Planning Department

RE: **Lot 11 Block 13 Unser Cliffs SAD 227**
8001 Fuji Ct NW
Grading and Drainage Plan
Engineers Stamp Date 1/15/18 (E10D029)
Pad Certification Date 9/5/18

ENGINEER'S SEAL 1/15/18 DAVID SOULE P.E. #14522	8001 FIJI COURT BRUNO RESIDENCE	DRAWN BY WCVJ DATE 1-11-18 21701-LAYOUT-1-10-17
	GRADING AND DRAINAGE PLAN 1606 CENTRAL AVENUE SE SUITE 201 ALBUQUERQUE, NM 87106 (505) 872-0998	SHEET # — JOB # 21701

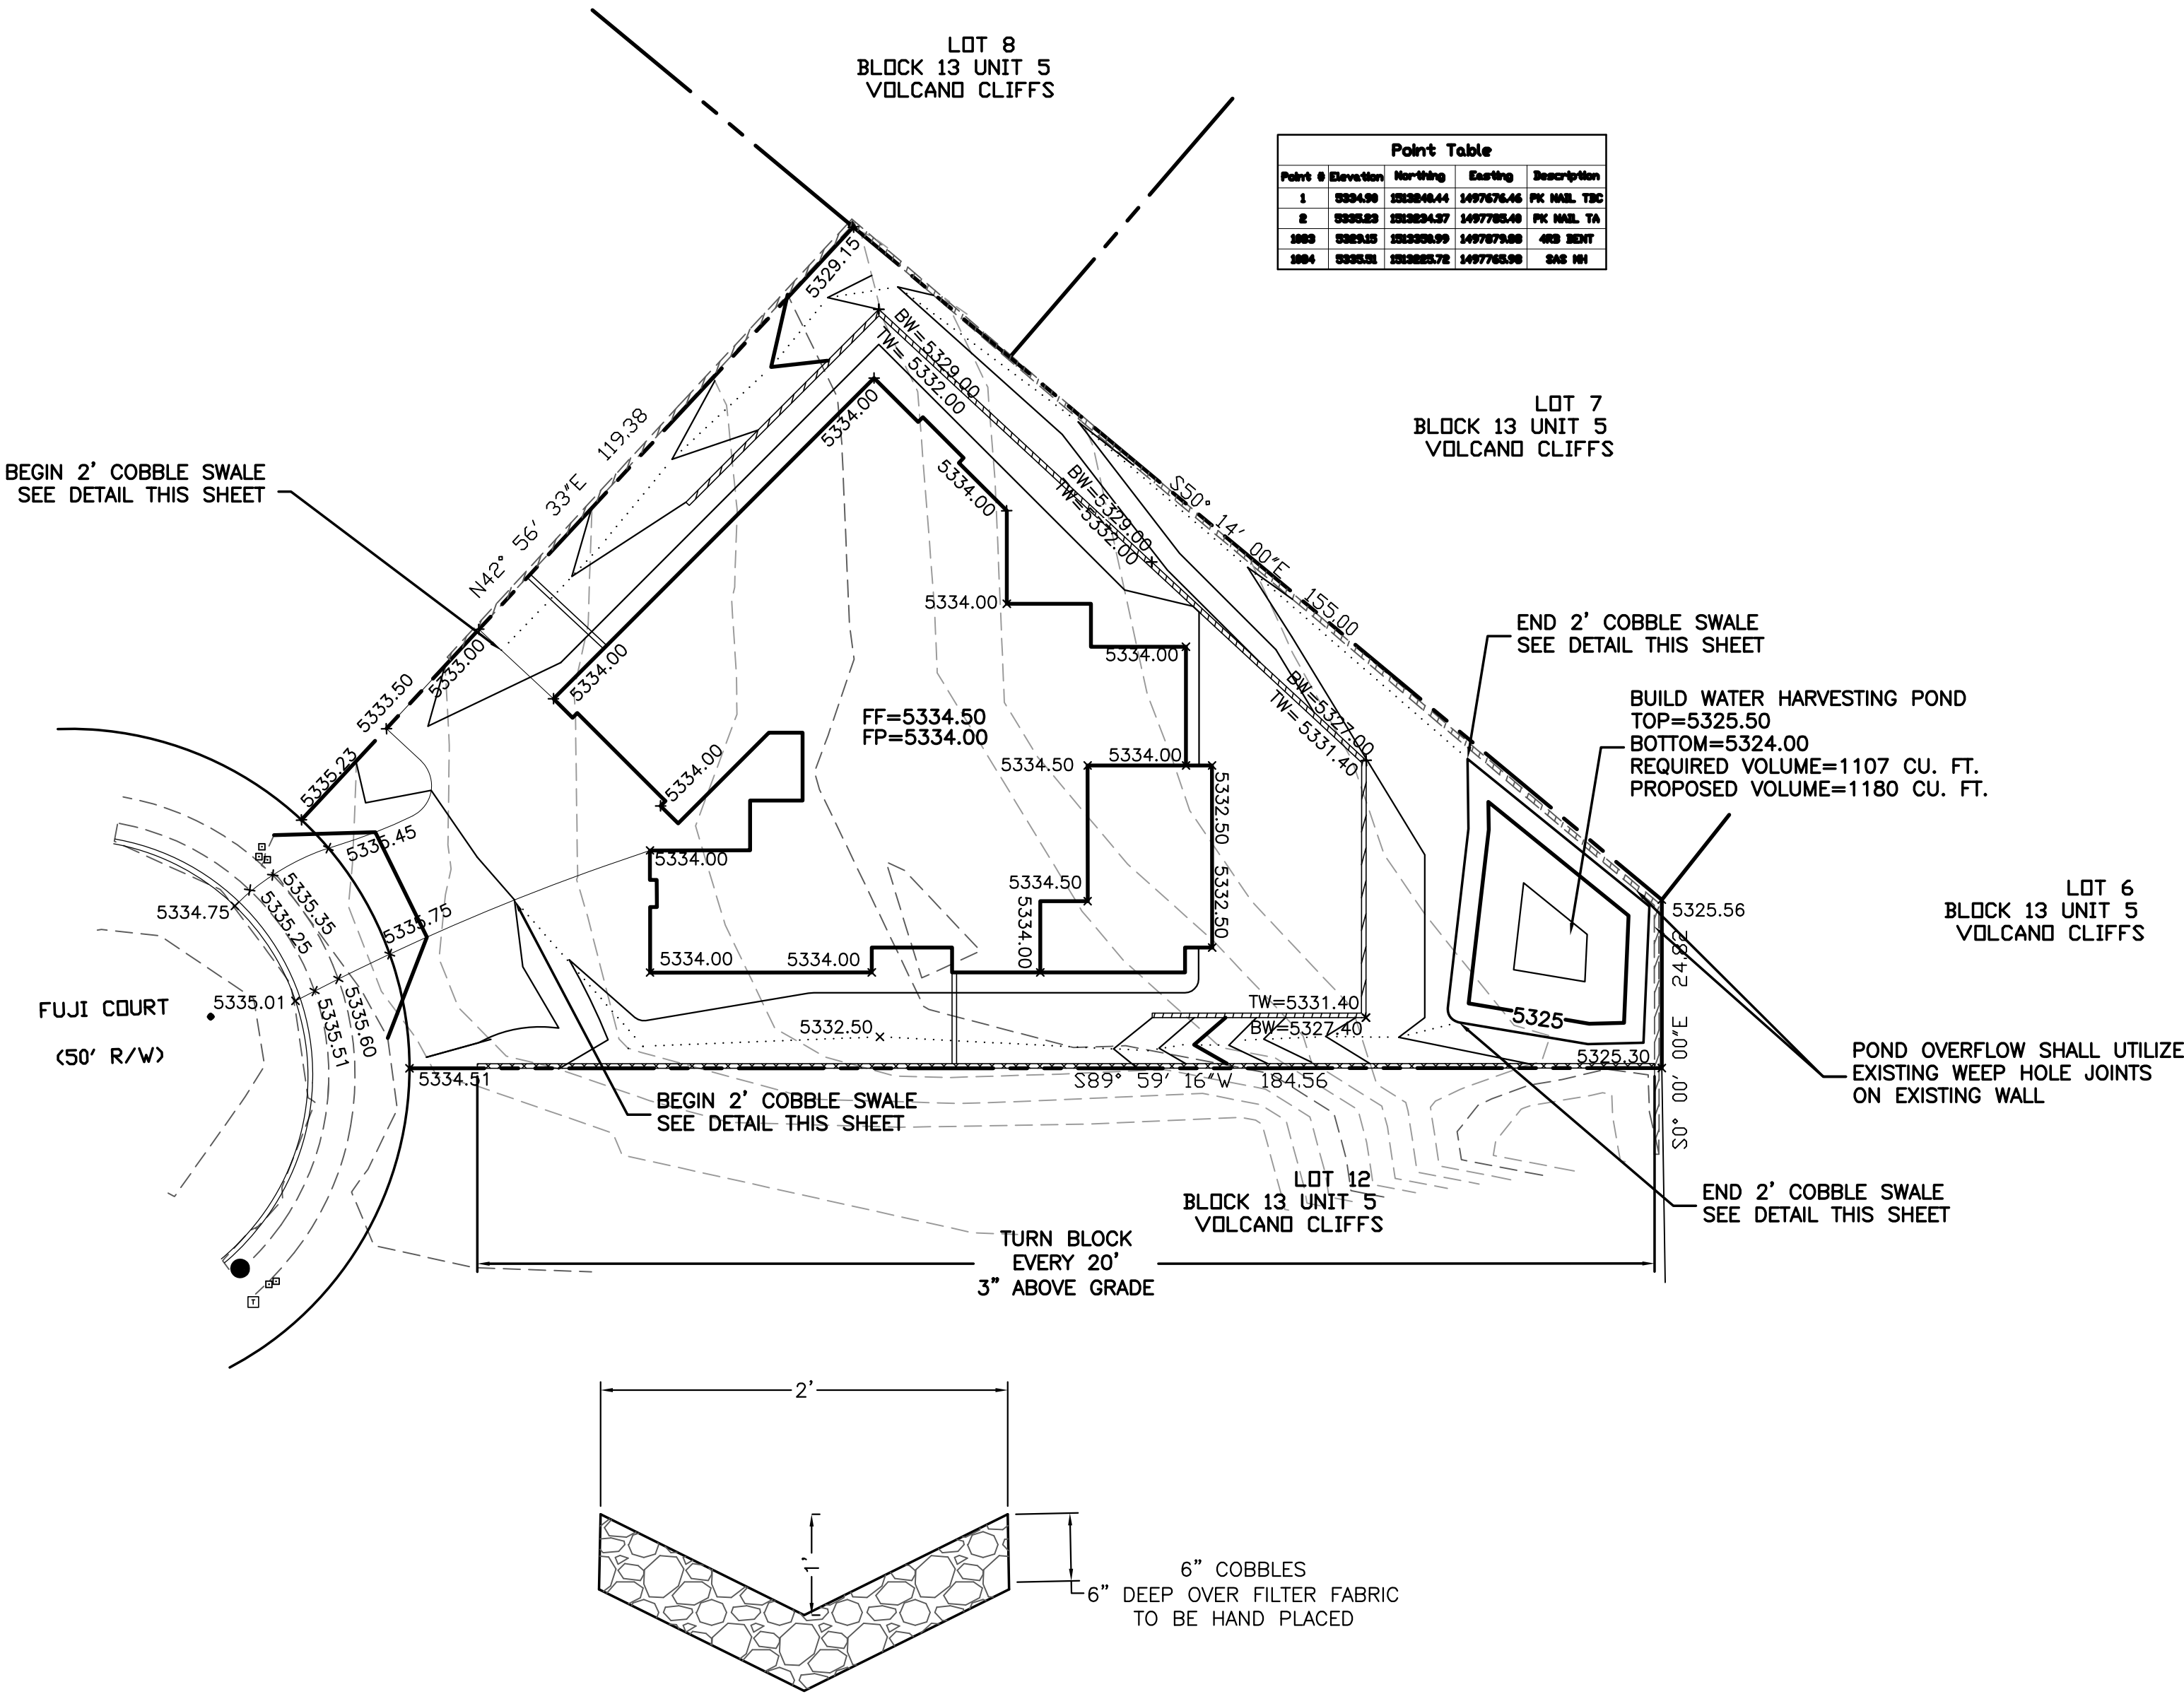
Based upon the information provided in your submittal received 9/6/18, this plan is approved for Building Permit.

Reiterate to the Owner/Contractor that a separate permit for a garden/retaining wall must be obtained, with the approved G&D plan dated 1/15/18.

Prior to Certificate of Occupancy release, Engineer Certification per the DPM checklist of this plan will be required.
